Addendum #1

**TAXILANE TB AND PERIMETER ROAD
REALIGNMENT PROJECT**

TAIT PROJECT #70722

December 5, 2025

ELECTRICAL PLAN

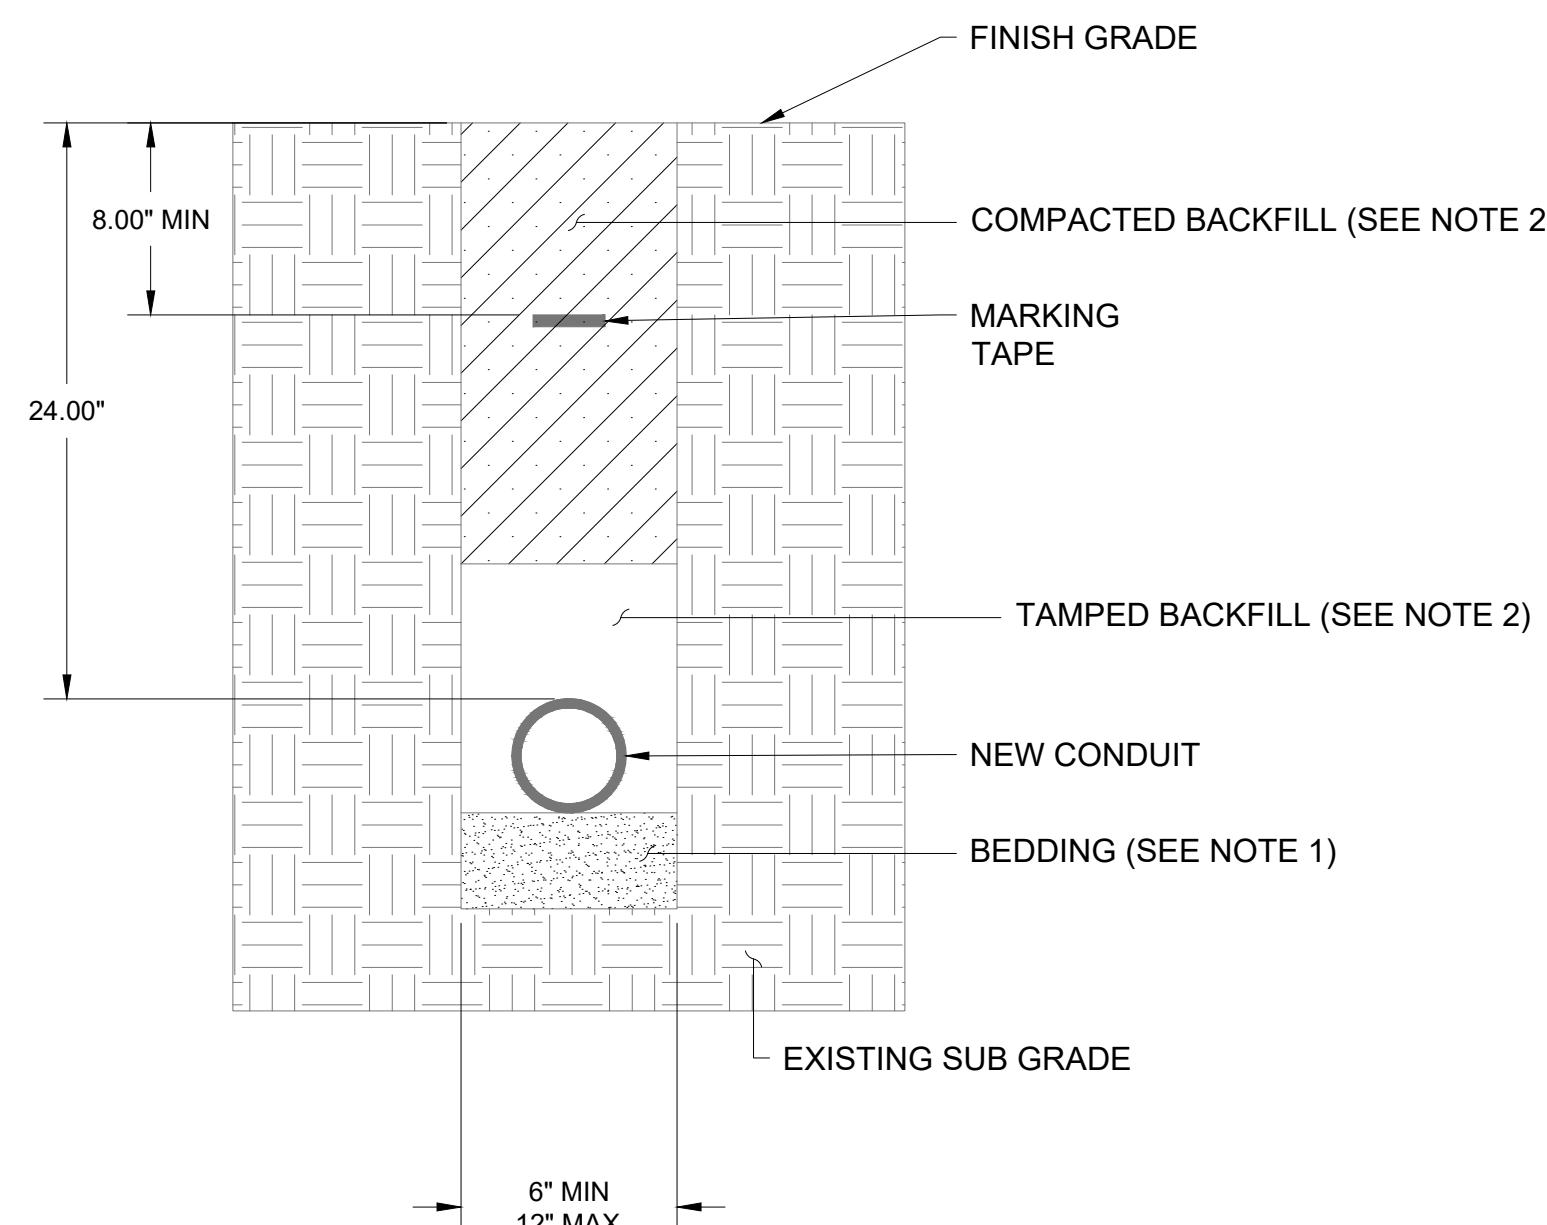
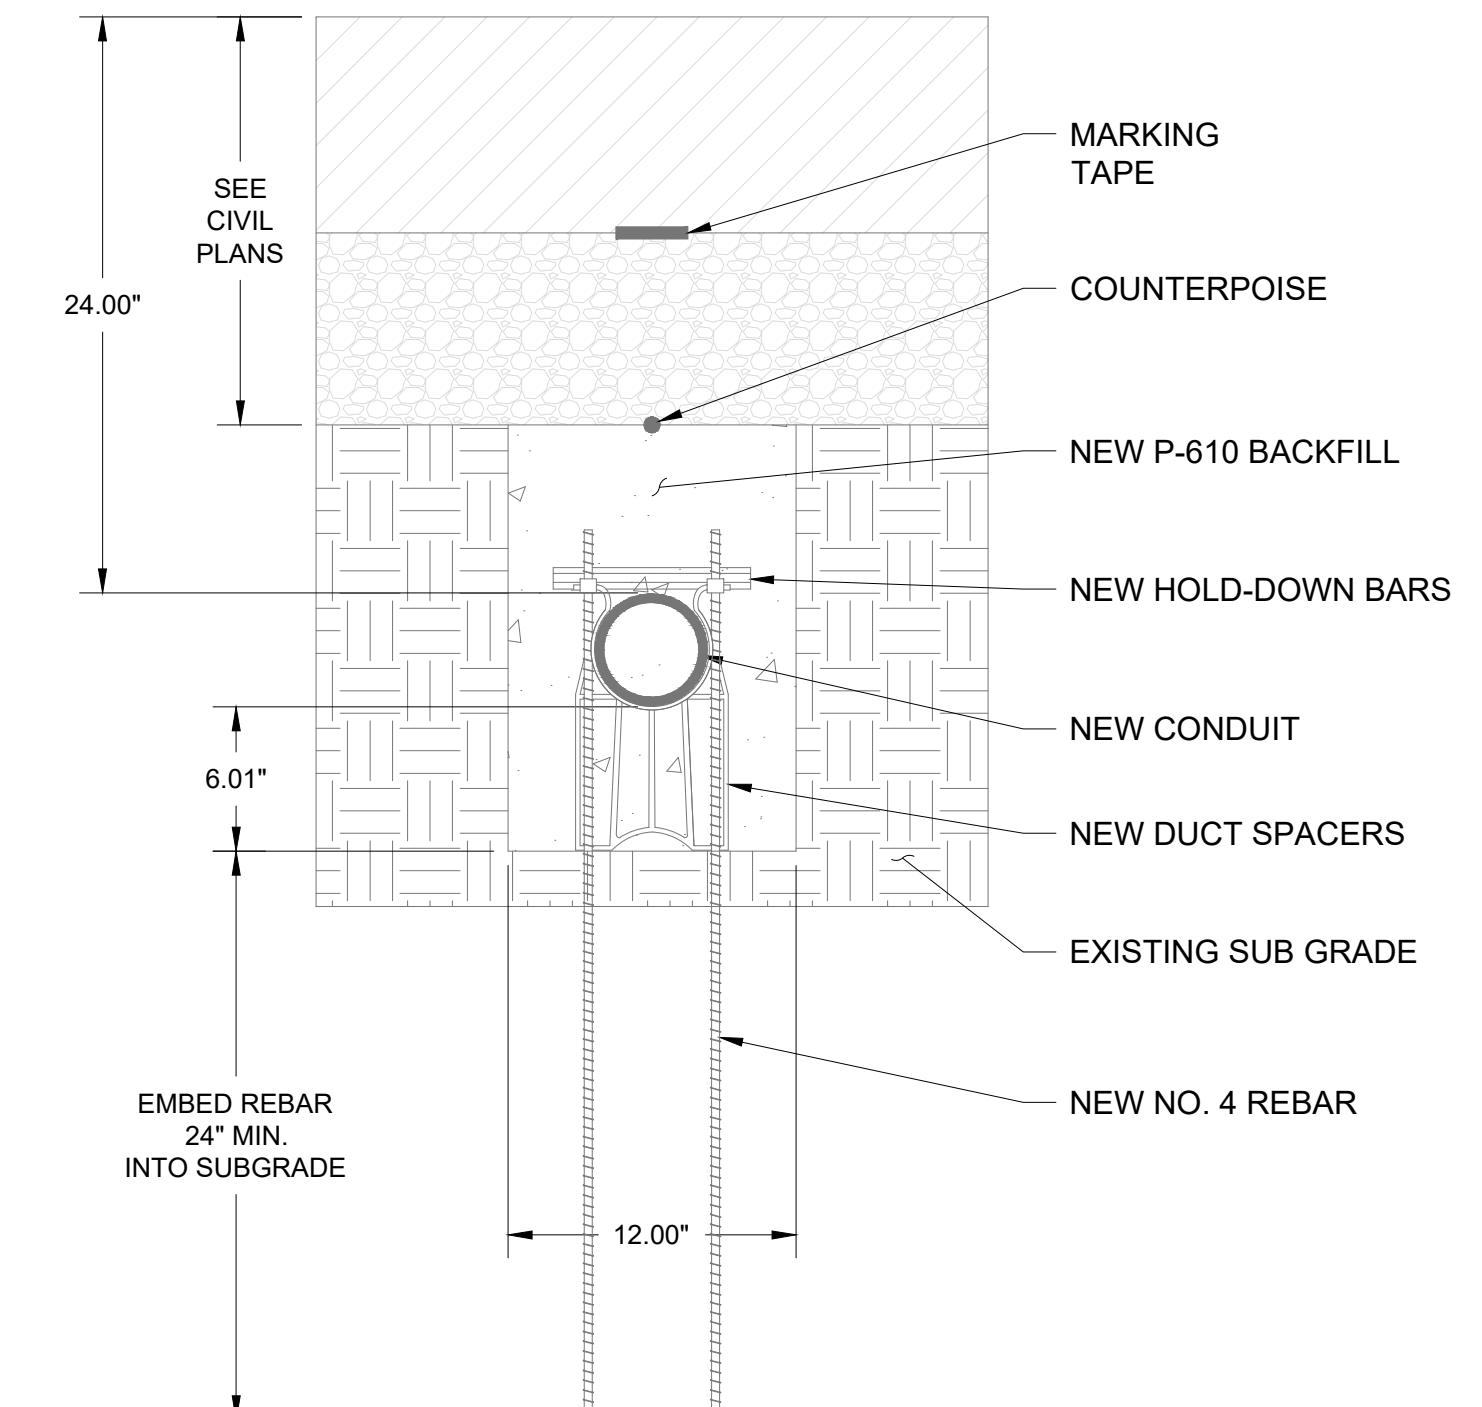
1. Replace plan sheets GN01.0001 (Index of Drawings and General Notes), GN01.0002 (Summary of Quantities, Legend & Abbreviation), EL01.0001 (Electrical Plan), and EL02.0001 (Electrical Details) of Project Drawings dated November 17, 2025, with the reissued Drawings that contain “Addendum 1” dated December 5, 2025, within the revision block.

- iii. Update to include additional/modified Electrical Design Parameters.
2. Add plan sheets EL02.0002 (Electrical Details 2) and EL02.0003 (Electrical Details 3) to Project Drawings dated November 17, 2025, with the new Project Drawings that contain “Addendum 1” dated December 5, 2025, within the revision block.

1 TYPICAL KEYPAD PEDESTAL DETAIL
EL02.0002 NTS

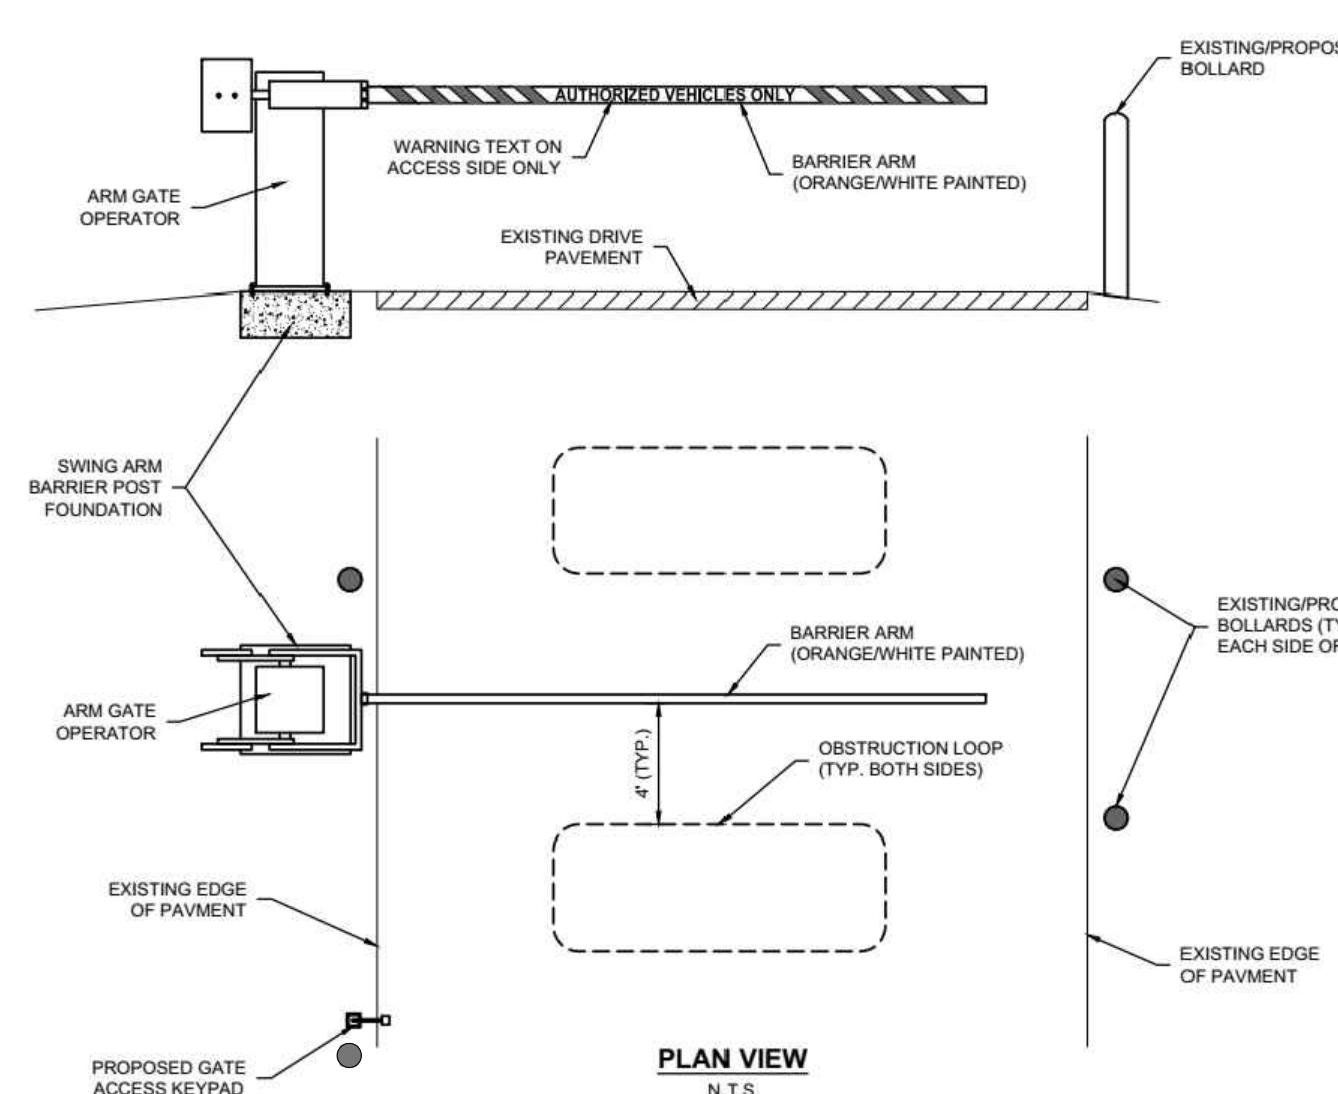
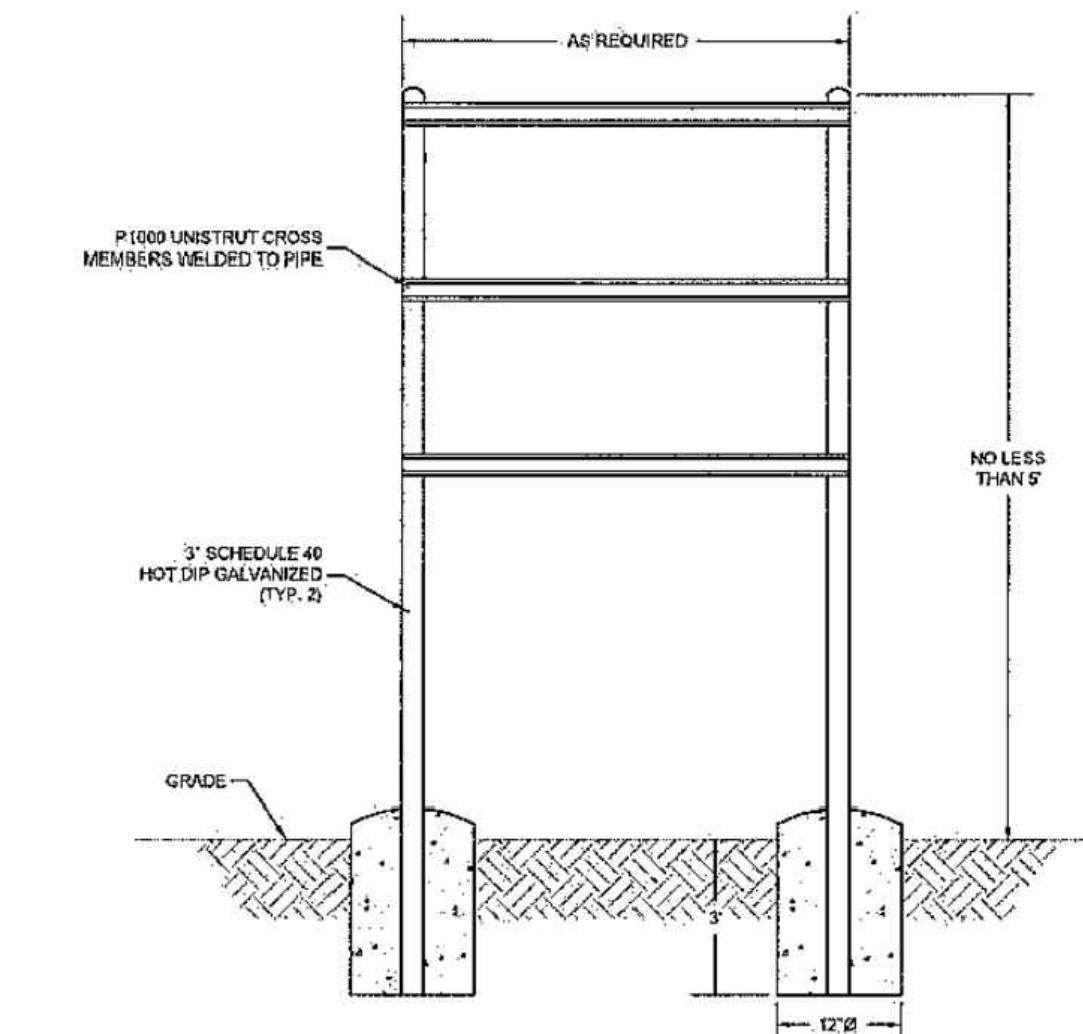
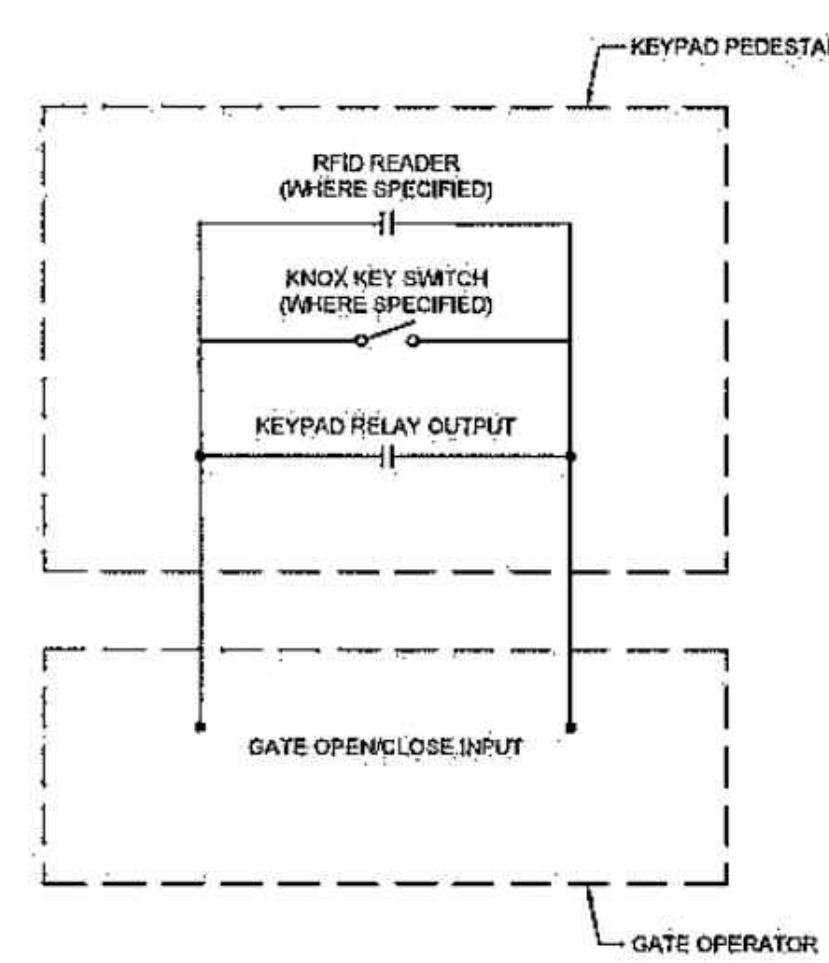
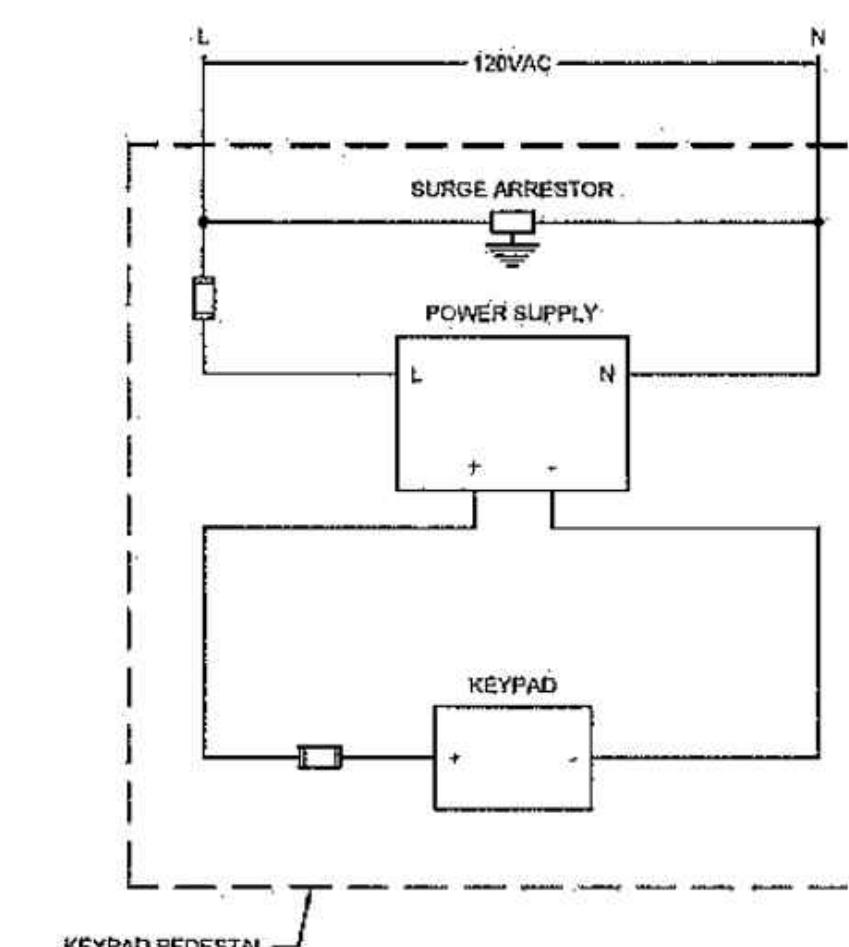
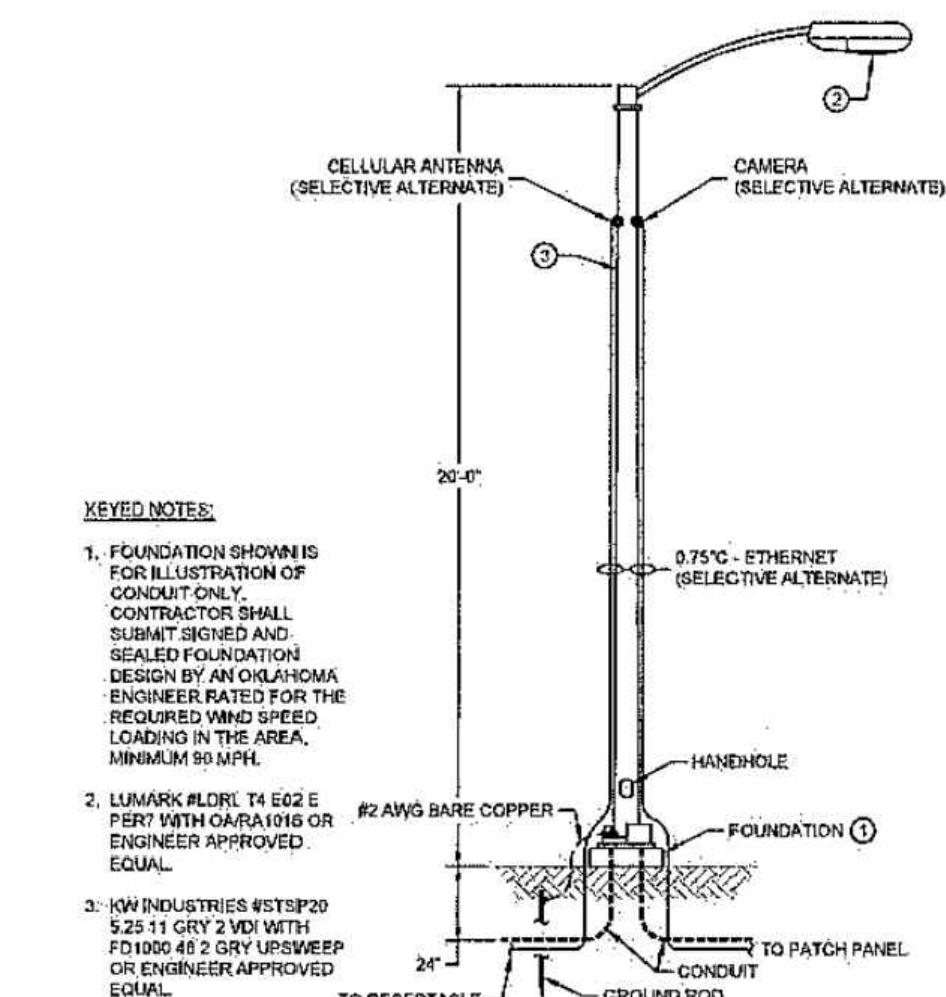
- a. Includes but are not limited to:
 - i. New Electrical Design Parameters.
